**CITY OF LINO LAKES
PLANNING & ZONING BOARD MEETING**

**PLANNING & ZONING BOARD
AGENDA ITEM 6A**

REQUEST: **PUBLIC HEARING** for 601 Apollo Drive Retail
 1. Text Amendment
 2. Site & Building Plan Review

Re: 601 Apollo Drive Retail
Plan Review
021123-000

SITE PLAN

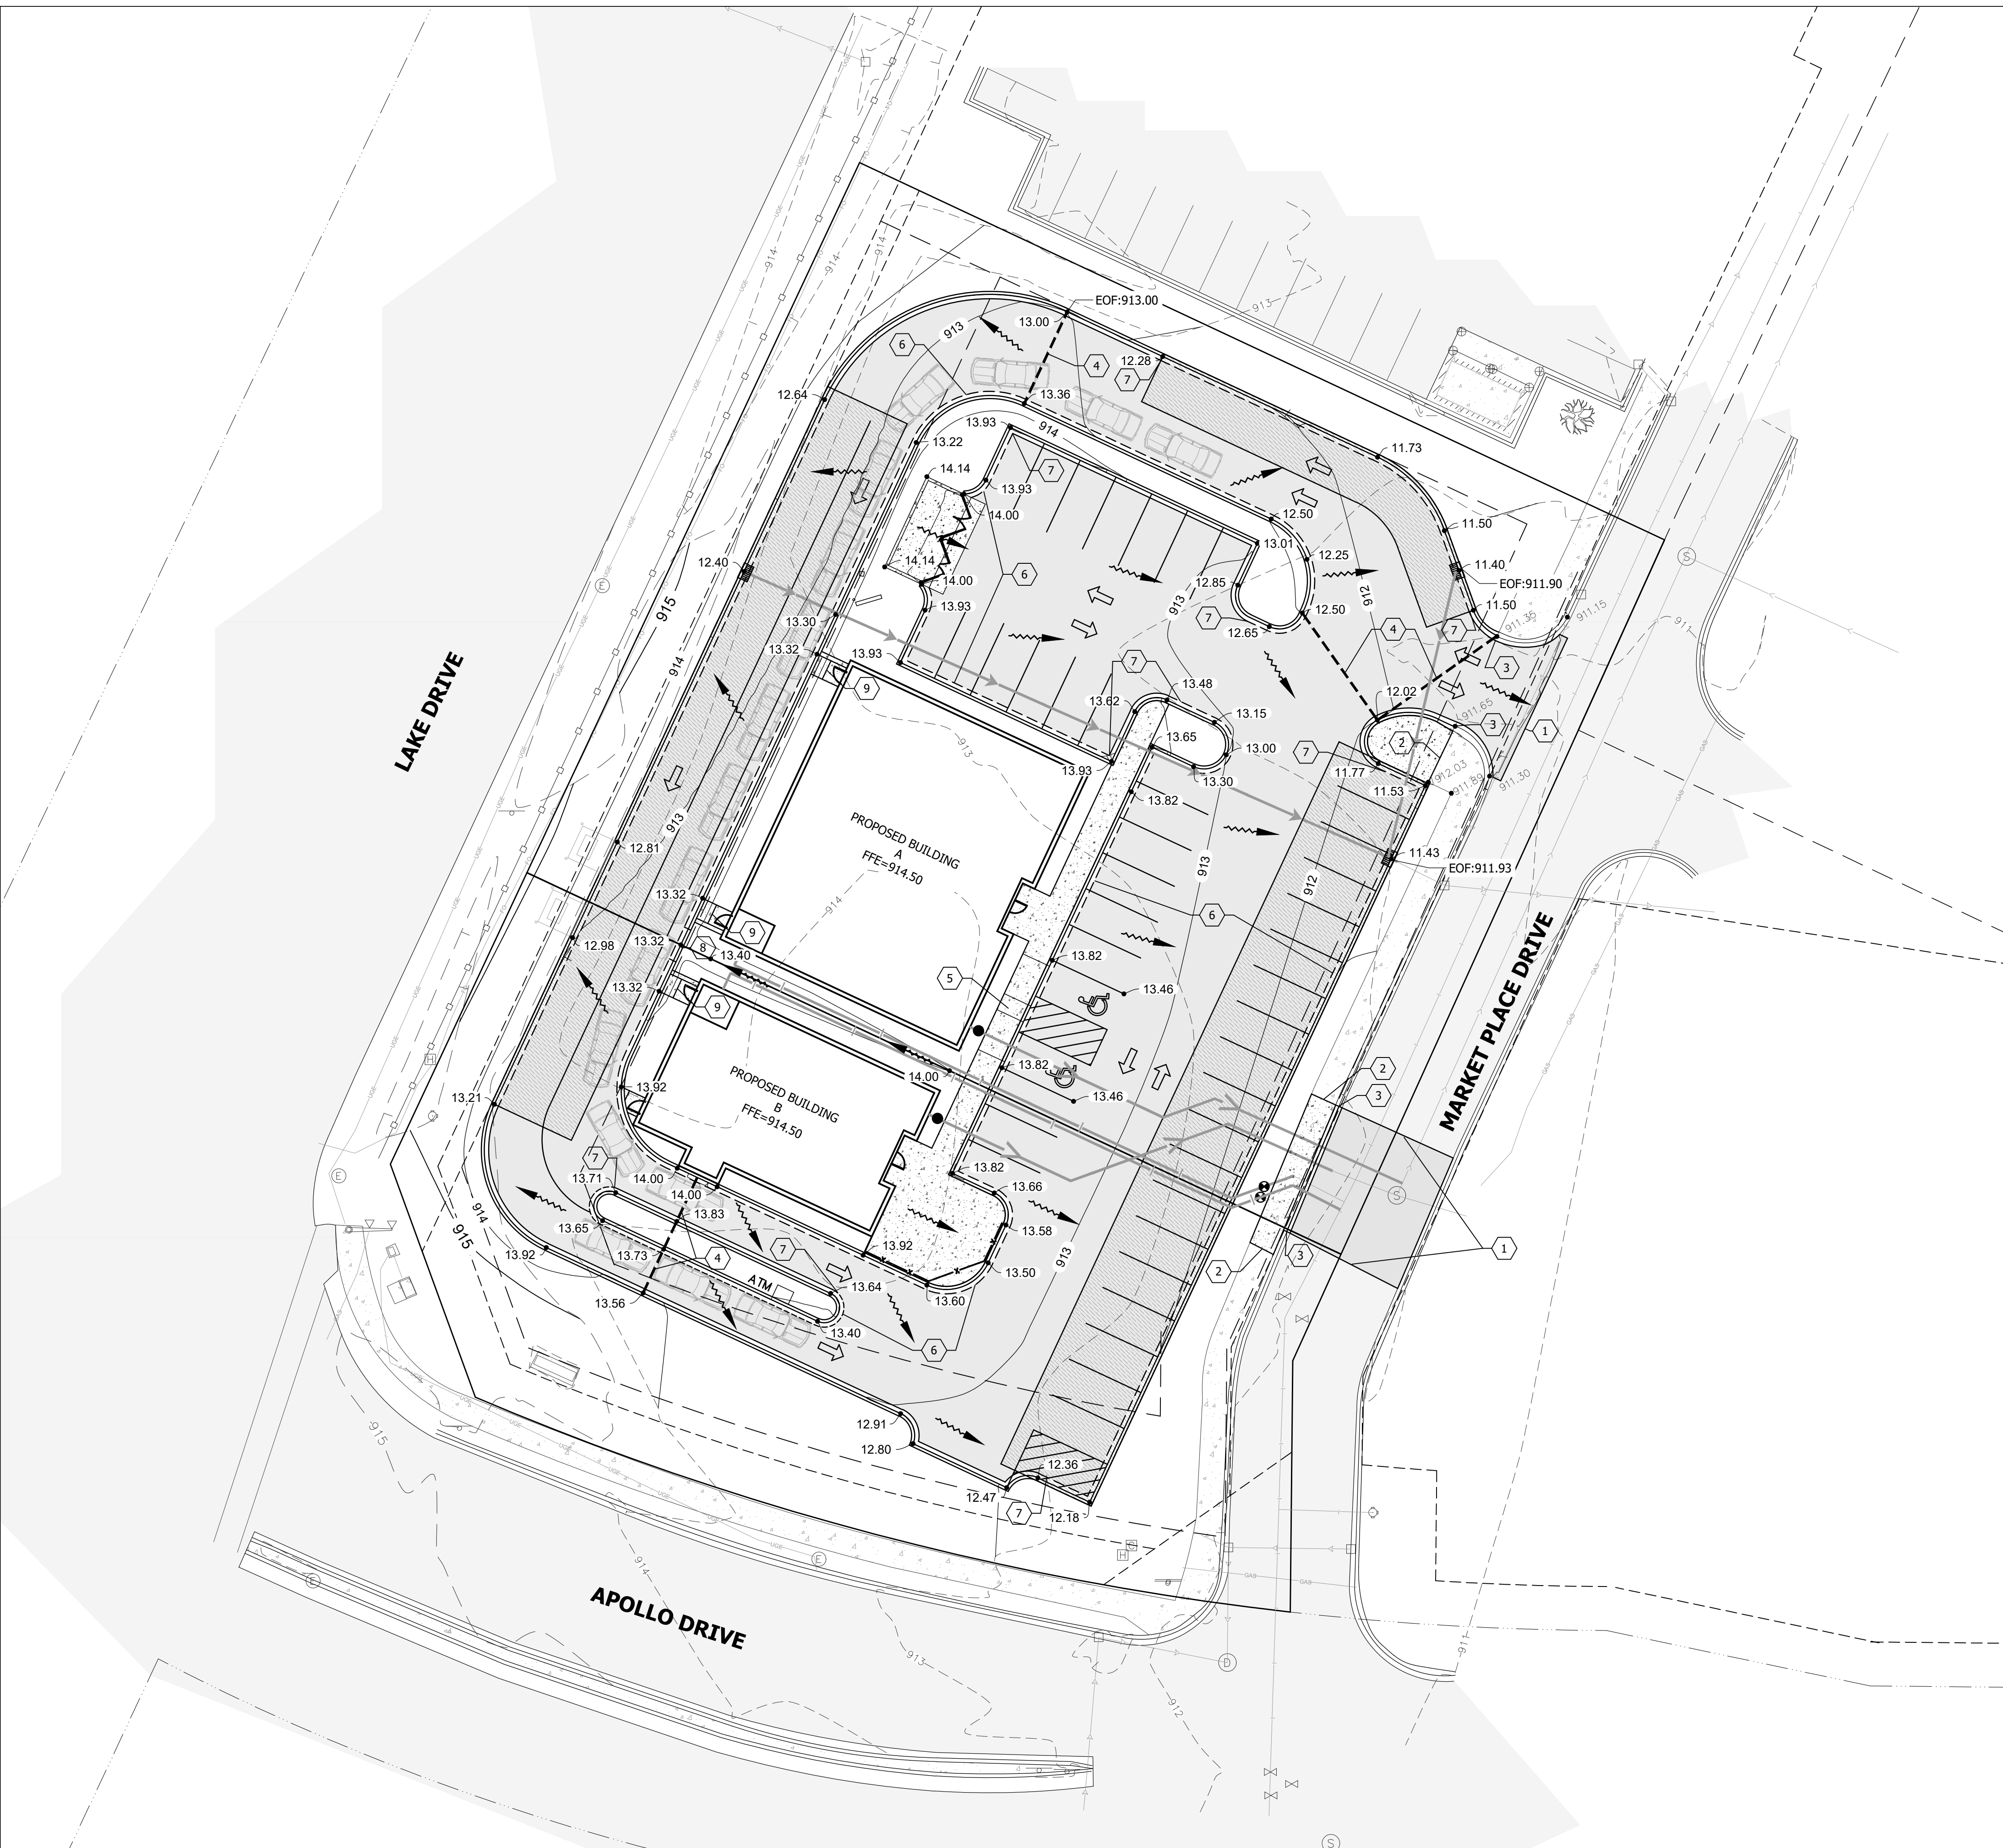
2. (9/7/2022) Applicant shall follow City of Lino Lakes Standard Detail GEN-6 for commercial parking lot entrances.
3. (9/7/2022) Areas of the parking lot that have two-way traffic must be at least 24-ft wide. Applicant to update the parking area north of the building.

4. (9/7/2022) Applicant to update drive-thru lanes to be 12-ft wide.
5. (9/7/2022) Applicant to add pavement markings or signage to designate which drive-thru lane is for the building and which is for the ATM. Applicant shall add markings or signage so that people do not enter through the exit of the drive-thru lanes.

6. (9/7/2022) Applicant to show a sidewalk connection to the parking lot near where the utility connections are being made. Pedestrian ramps shall be installed at the parking lot entrance (see Standard Detail GEN-26).

GRADING PLAN

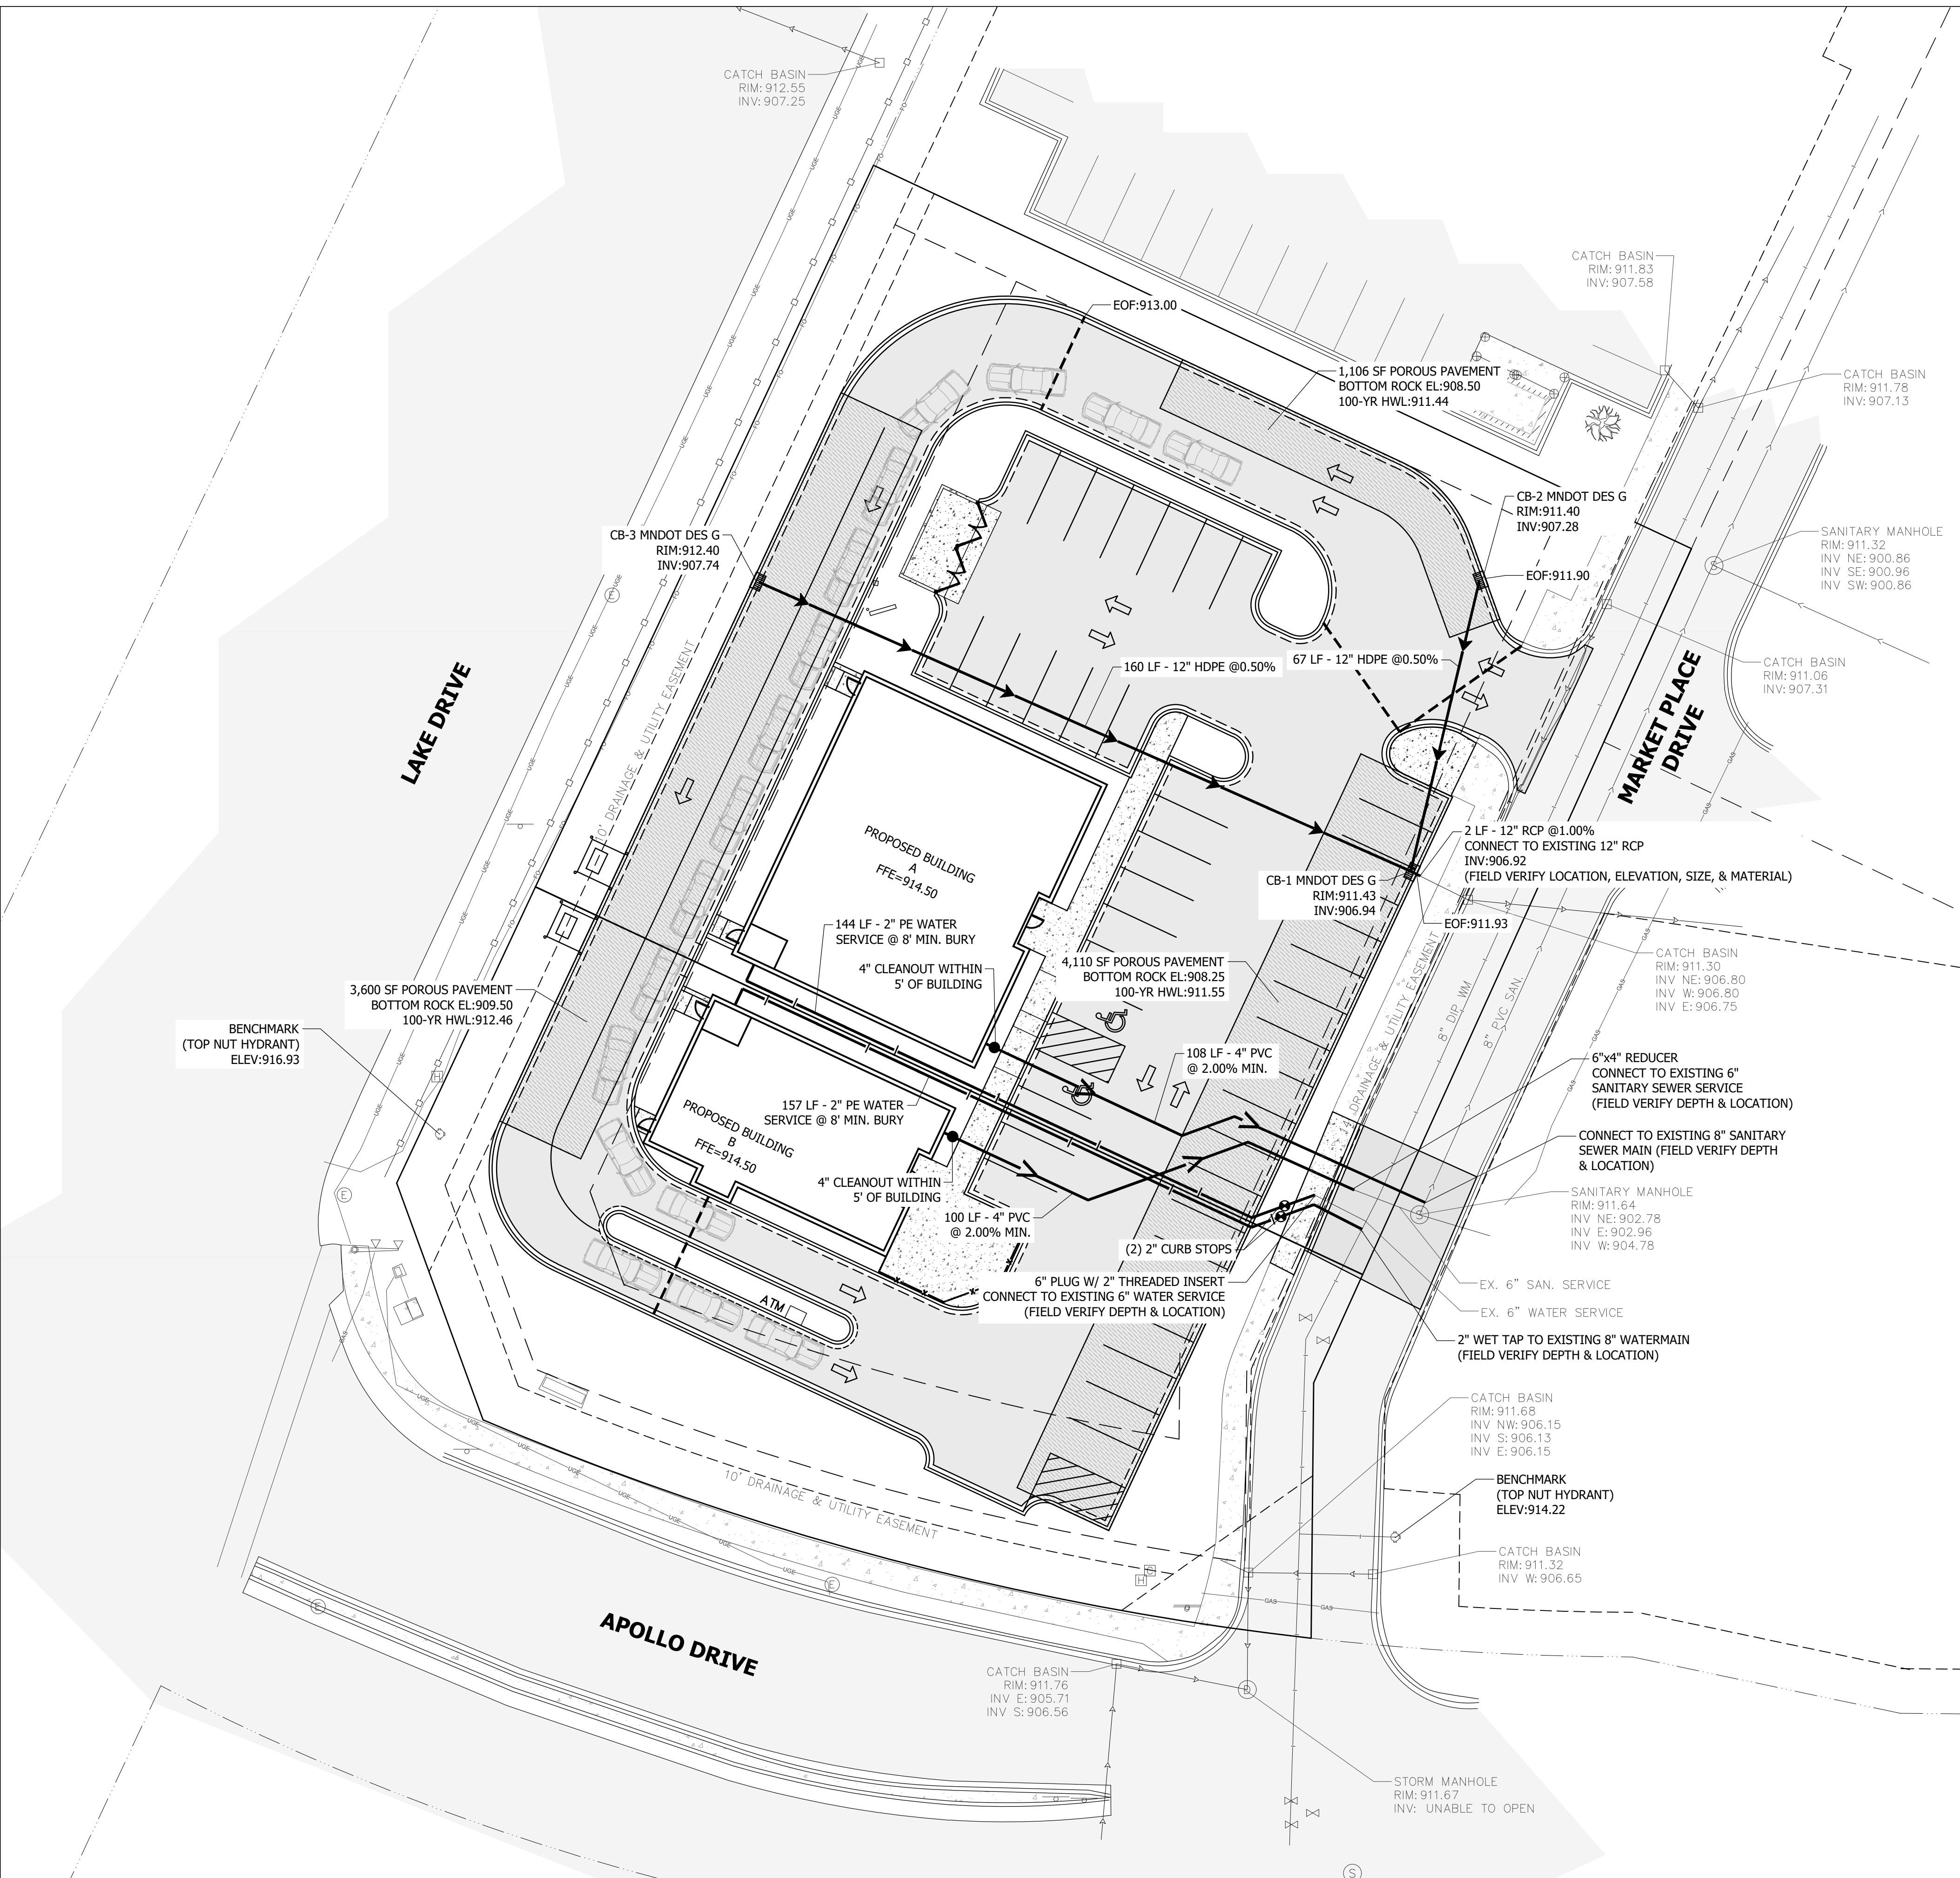
1. (9/7/2022) Applicant to verify that low floor elevations are at least 4-ft above groundwater elevations.

- (9/7/2022) Applicant to review parking lot grading along the west side of the lot/drive-thru lanes. It appears that the 915 contour is cut off by the proposed 914 contour. Note that the city does plan on installing a trail in the easement. Please take a future trail into consideration when revising the grading.
